## Product Change Notification / SYST-25YQMY847

ERRATA - PIC16(L)F15325/45 Family Silicon Errata and Data Sheet Clarification Errata Document Revision

## PIC16(L)F15325/45 Family Silicon Errata and Data Sheet Clarification

#### 2.1 Figure 37-5: Clock Timing

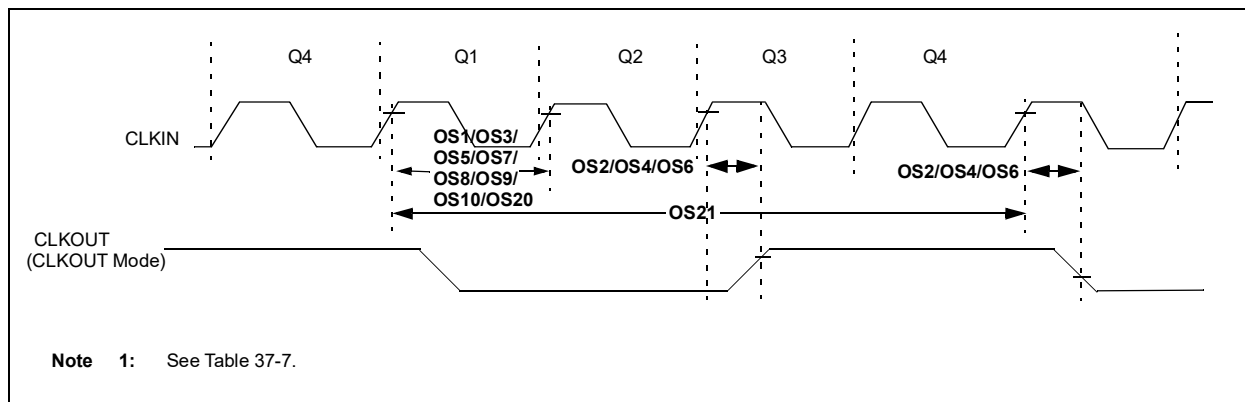
Figure 37-5 incorrectly shows the location of parameters OS1, OS2, OS3, OS4, OS5, OS6, OS7, OS8, OS9, OS10, OS20 and OS21. The correct location for the above-mentioned parameters is depicted in the following figure.

#### 2.2 Figure 37-9: Brown-Out Reset Timing and Characteristics

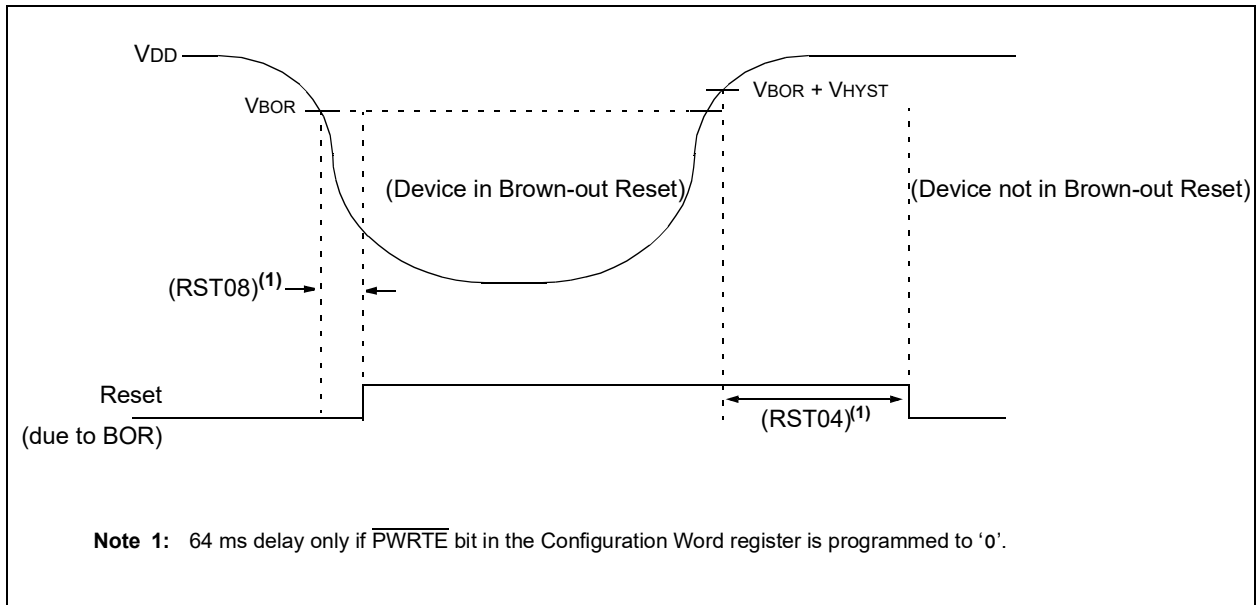
Note 1 in Figure 37-9 is incorrect. The correct note along with the figure is depicted below.
